**WHITE LAKE TOWNSHIP
INTER-OFFICE MEMORANDUM
COMMUNITY DEVELOPMENT DEPARTMENT**

**SUBJECT: Jax Car Wash
Preliminary site plan approval**
The property is described as parcel number 12-20-276-034, located on the northwest corner of Highland Road (M-59) and Bogie Lake Road, consisting of approximately 1.88 acres, currently zoned (PB) Planned Business District.

RE: Jax Kar Wash- Preliminary Site Plan Review – 2nd Review

**Preliminary Site Plan / Planned Business Review
for
White Lake Charter Township, Michigan**

40LF Aerial Fire Truck
Overall Length 40.000ft
Overall Width 8.167ft
Overall Body Height 7.500ft
Min Body Ground Clearance 0.750ft
Track Width 8.167ft
Lock-to-lock time 5.00s
Max Wheel Angle 45.00°

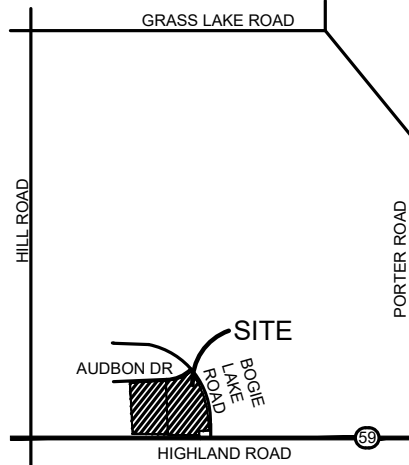
- g) *Provide fire truck turning radii plan that also demonstrates ingress, internal circulation, and egress of a standard 40' length fire truck on the site. Comment addressed. Fire truck turning radii plan has now been provided.*

PRE-DEVELOPMENT DRAINAGE MAP
NOT TO SCALE

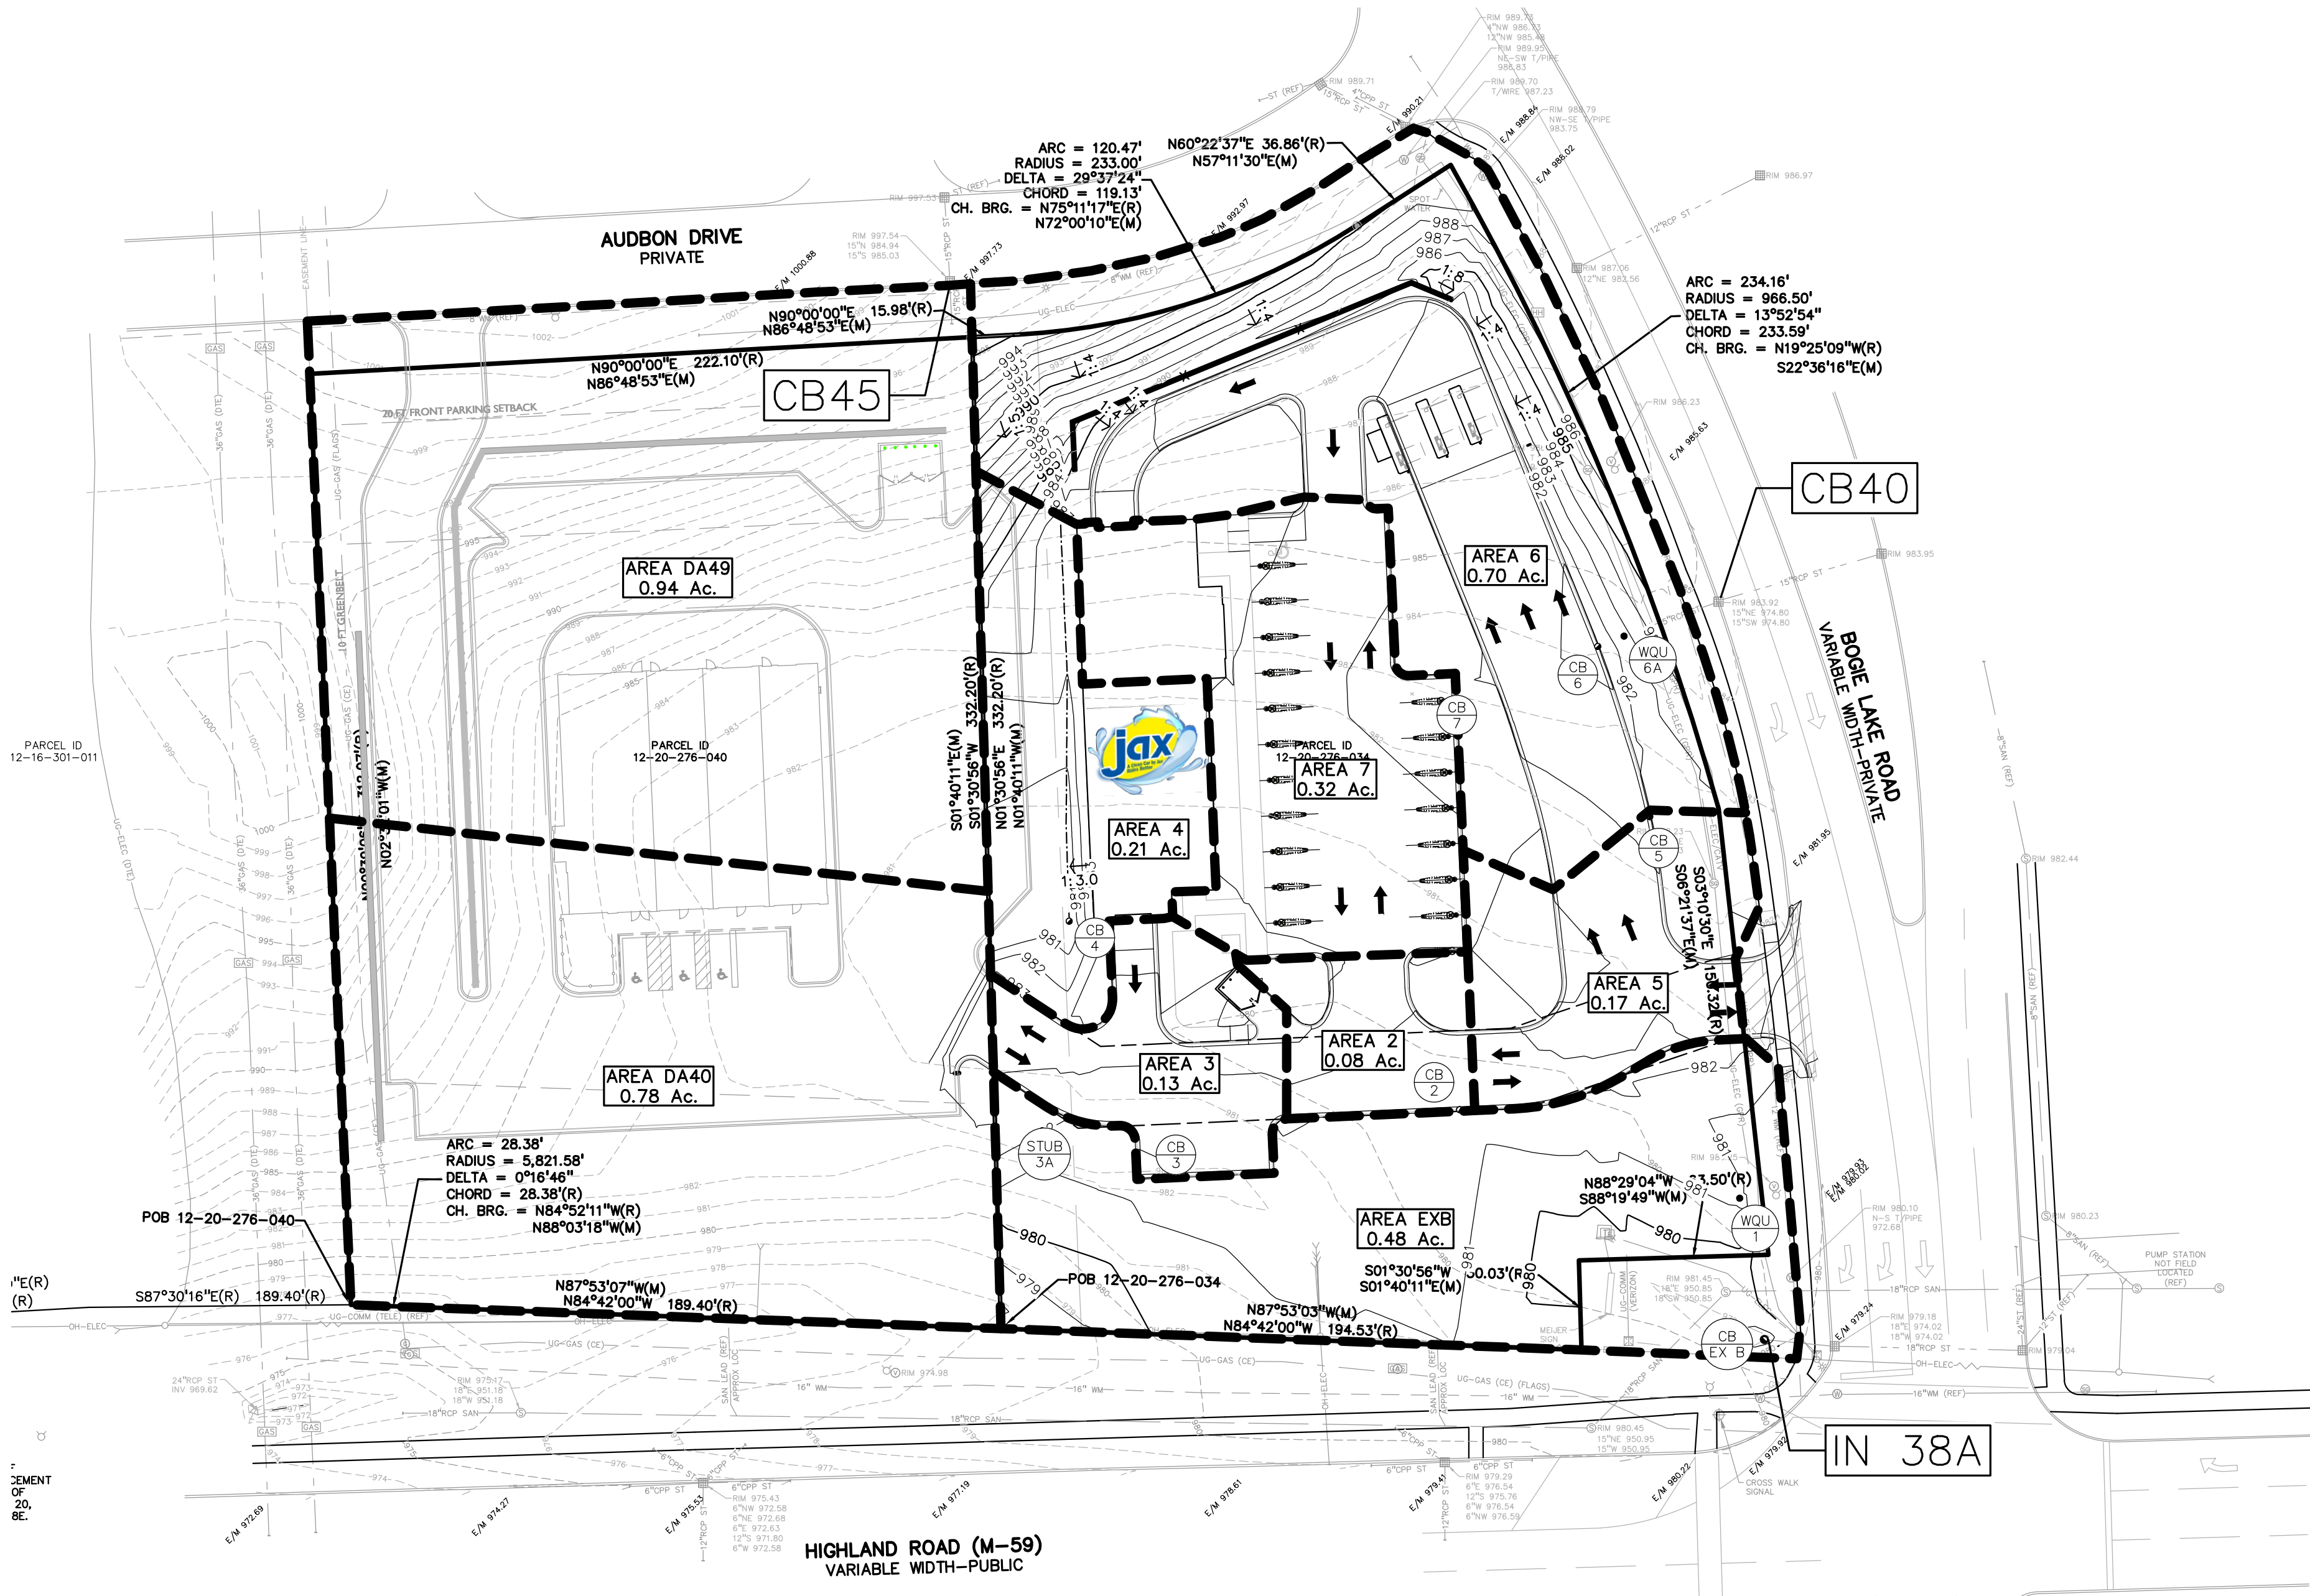
- p) *Show pre versus post development storm drainage that is being routed to the existing storm sewer structure near the corner of Highland Road and Bogie Lake Road. **Comment addressed. Calculations have been provided, and it has been demonstrated that there is sufficient capacity in the existing storm sewer to accommodate developed flows.***

CONCRETE PARKING BUMPER
NOT TO SCALE

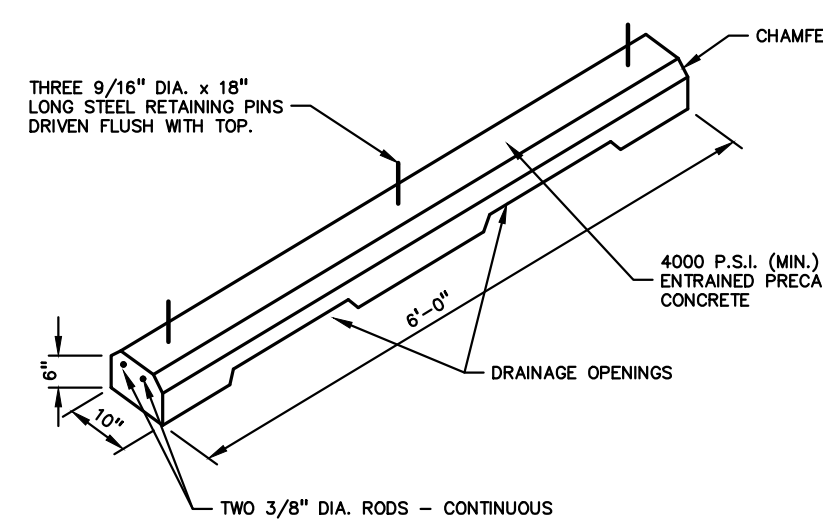
- e) *Clarify why the two proposed parking spaces at the SE corner of the vacuum area have bumper blocks shown. Currently curbing is proposed so there would be no need for bumper blocks. We note there is also a bumper block detail shown on Sheet C-9.0. We also note that the architect's exterior rendering showing the ADA space up close, shows bumper blocks. Please check that all plans are consistent with what is intended for parking spaces. Comment partially addressed. The bumper blocks have been removed; however, please remove bumper block detail from Sheet C-9.0 and bumper blocks on the architects rendering, as stated in our original above comment.*

ORNAMENTAL FENCE DETAIL
NOT TO SCALE

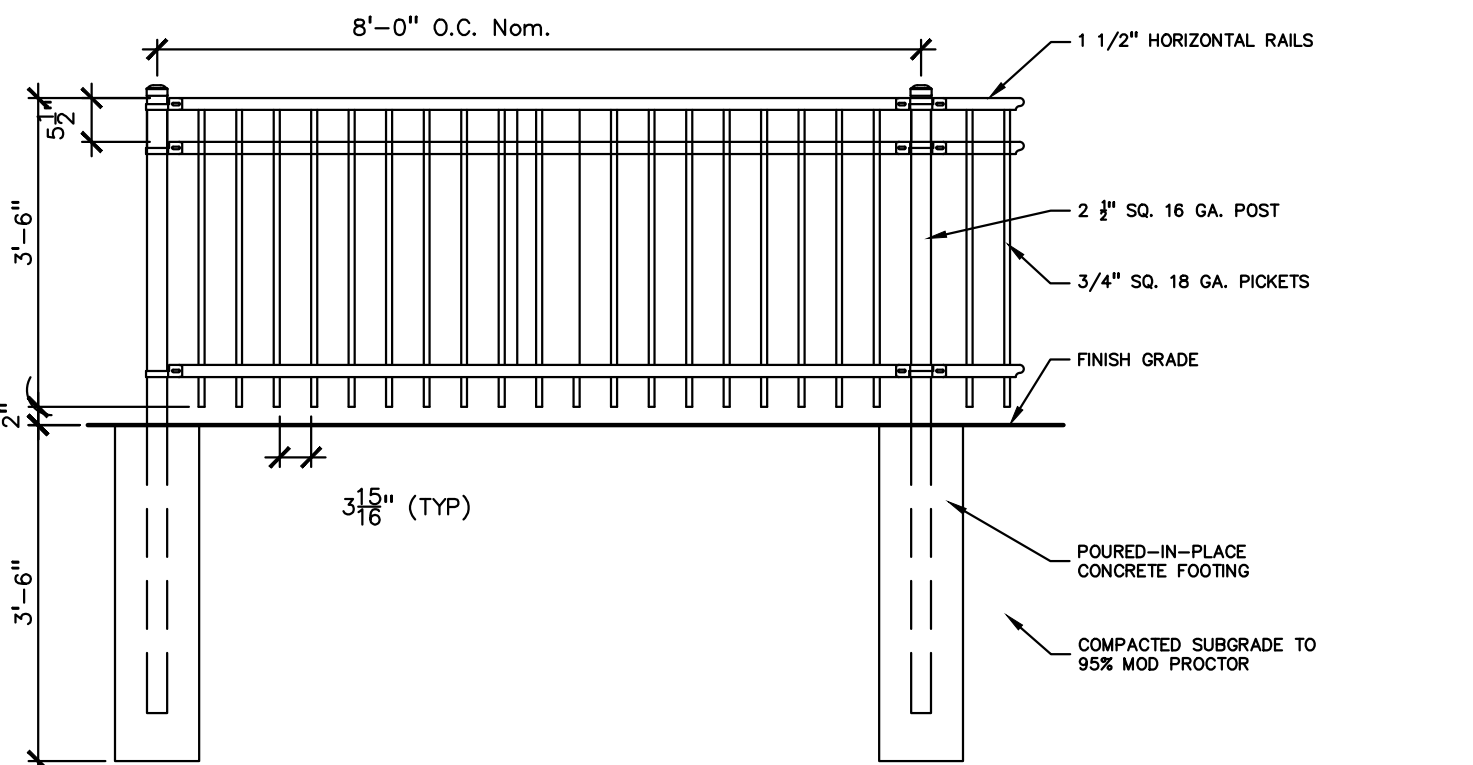
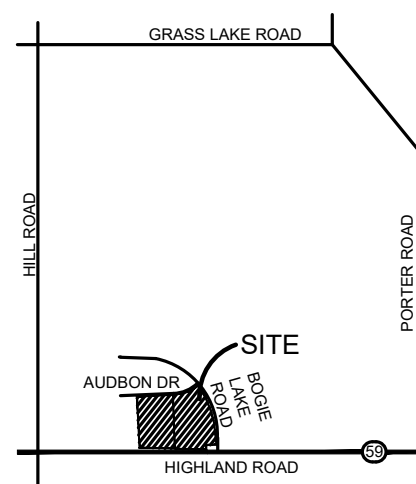
- o) *Sheet C-9.0-Chain Link Fence Detail- We defer to the Township as to whether the fence shall be decorative or whether chain link is acceptable. The fence shall be a minimum of 42" in height. Please reference White Lake Township Engineering Design Standards Section B.6. which states "Any portion of a retaining wall more than 30" high shall have provided at the top of said wall a decorative railing not less than 42"high (non-residential uses) meeting the requirements of Section 1012.3 of the Michigan Building Code." **Comment partially addressed. Fence is now indicated on Sheet C-3.1 to be a 42" high decorative fence. Please remove Chain Link Fence Detail on Sheet C-9.0.***
